Service Bulletin

Date: 10 July 2020

Subject: Tire pressure label

Product: Brutale 1000 Serie Oro - RR from vin ... LV000011 to vin ... MV000294

NON-CONFORMING PART IDENTIFICATION PROCEDURE:

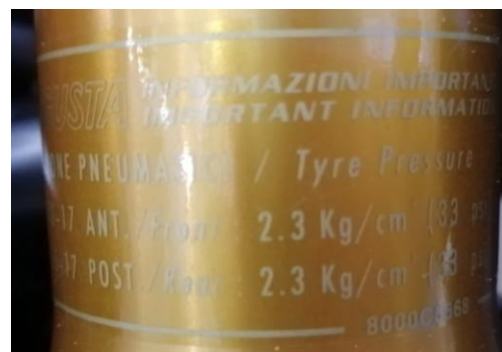
Following a continuous monitoring of the quality of our product, it has been found that for the Brutale 1000 Serie Oro - RR motorcycle purchased by you, it is necessary to replace the label showing the indication for the tire pressure, reporting incorrect values for the model in object.

It will be possible to identify the part that needs to be replaced by observing the pressure values shown on the label placed on the right fork leg and identified by the cod. 8000C5568;

All labels showing values other than those listed above must be replaced.

The correct tire pressure values for the B4 1000 Serie Oro and RR are the following:

Front tire: 2.3 bar (cold condition)

Rear tire: 2.3 bar (cold condition)
